Stage 1 Road Safety Audit

**Residential Development, Shanganagh Castle,
Cork Little, Co. Dublin**

On behalf of **Dun Laoghaire Rathdown County Council**

December 2019

2.2.1 Internal Road Geometry

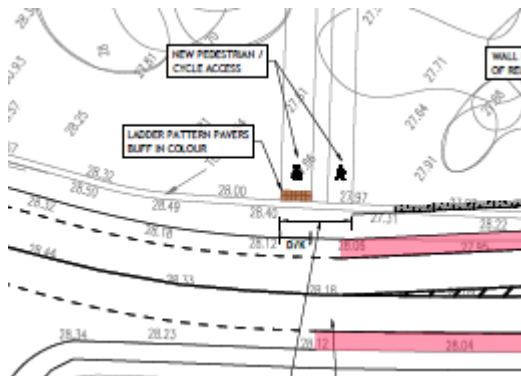
Problem: Long straight and sweeping curved roads are proposed for the internal arrangement.

Hazard: High vehicle speeds may result in impact with cyclists or crossing pedestrians.

Recommendation: Provide an alternative roads layout that incorporates the desires of the Design Manual for Roads and Streets.

2.2.1	N	N	The design of the street layout for the site reflects an orthogonal system as per DMURs. In order to reduce traffic speeds the site will be sign posted with 30kph speed limit and additionally speed tables/changes of materials will be constructed to encourage lower speeds internally	Yes

2.3.1 Signalised Junction Location

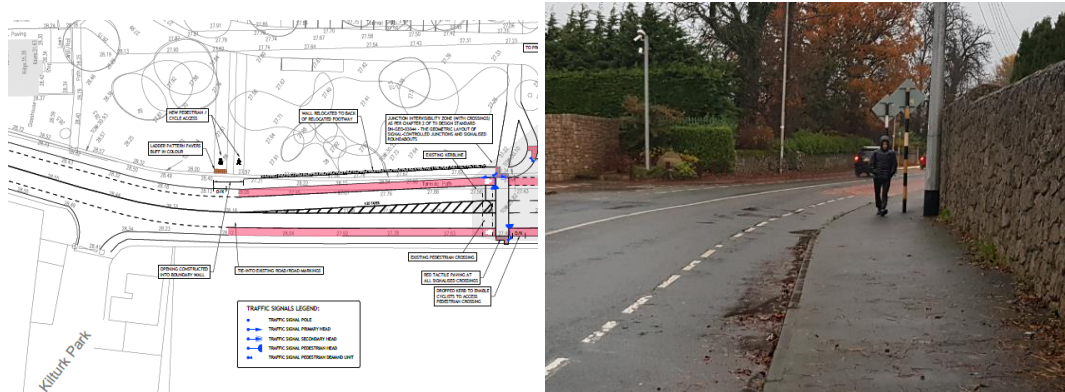
Problem: The proposed signalised junction is likely to result in queuing of vehicles on the R119. This is of concern where vehicle queues extend back on the southbound approach as there is a bend in the road with limited forward visibility in advance of the junction.

Hazard: Rear end shunts may result.

Recommendation: Relocate the junction further to the south.

Note: Combining this signalised junction with the Allies River Road junction may provide betterment to the existing junction arrangement.

2.3.1	N	N	Sufficient Sight Stopping Distance is provided at the junction for all queue lengths. Refer to 182134/SK32. Additionally, warning signage will be provided of the new signalised junction to warn drivers of the new signalised junction.	Yes

2.3.2 Signalised Junction - Capacity

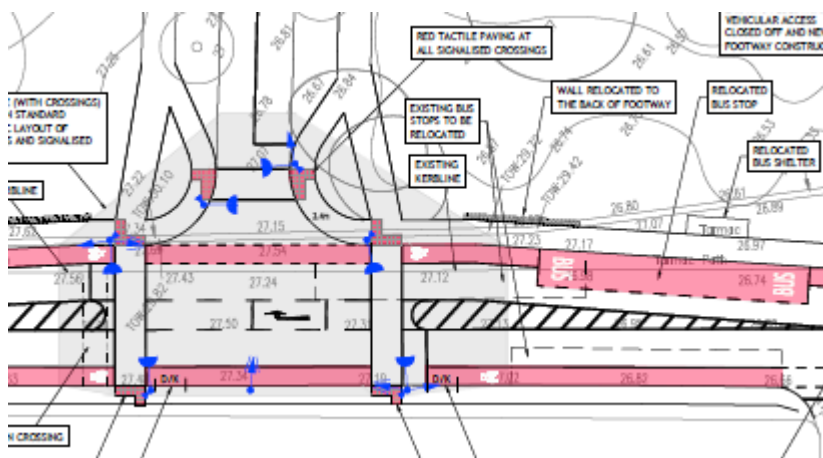
Problem: The right-turning lane for traffic to access the development from the south is very short. Right turning vehicles may queue back into the through lane.

Hazard: Driver frustration may result in northbound users breaking the red signal in order to clear the junction.

Recommendation: Ensure the right-turning lane is sufficiently long to accommodate the anticipated demand.

2.3.2	N	N	The capacity of the signalised junction has been evaluated for the forecast traffic loading and concluded that queuing for only one car is necessary. There will effectively be sufficient space for two vehicles to queue for the right turn when the space behind the turning bay is included.	Yes

2.3.3 R119 Bus Stops - Stagger

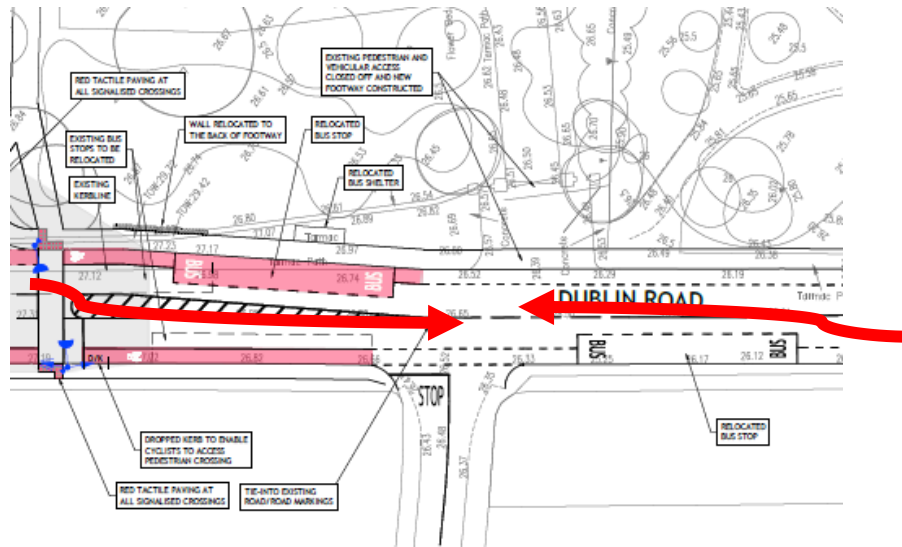
Problem: The relocated bus stops are separated by a short distance whereas the existing bus stop arrangement is directly opposite each other. If both stops are occupied simultaneously following traffic can now attempt to overtake the waiting bus.

Hazard: Opposing overtaking vehicles may meet in the middle of the road. Head-on impact may result.

Recommendation: Relocate the bus stops to ensure the problem above does not result.

2.3.3	Y	N	It is proposed that the bus stop on the southbound lane be omitted. As there is an existing bus stop c. 120m north of this location it could reasonably be concluded that bus users would access that one via the site pedestrian access c. 60m north of the signalised junction. It is worth noting that the Busconnects proposals omits this bus stop.	Yes

2.3.5 R119 Eastern Bus Stop

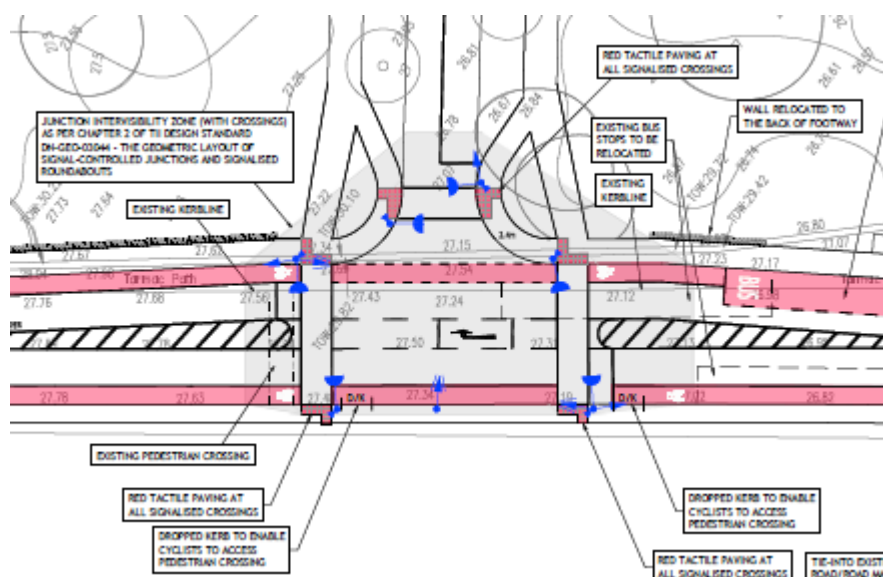
Problem: The bus stop is close to the signalised Junction. The ghost island road markings make overtaking of the bus stop an illegal movement. Following traffic may queue through the junction. Upon departure of the bus following traffic may ignore any change to a red signal and drive through the junction.

Hazard: Impact with vehicles now offered a green light may result.

Recommendation: Relocate the bus stop.

2.3.5	Y	N	Refer to 2.3.3	Yes
2.3.6	Y	N	'Cyclist Dismount' markings will be applied to the footpath at the west side of Dublin Road at the signalised crossing.	Yes
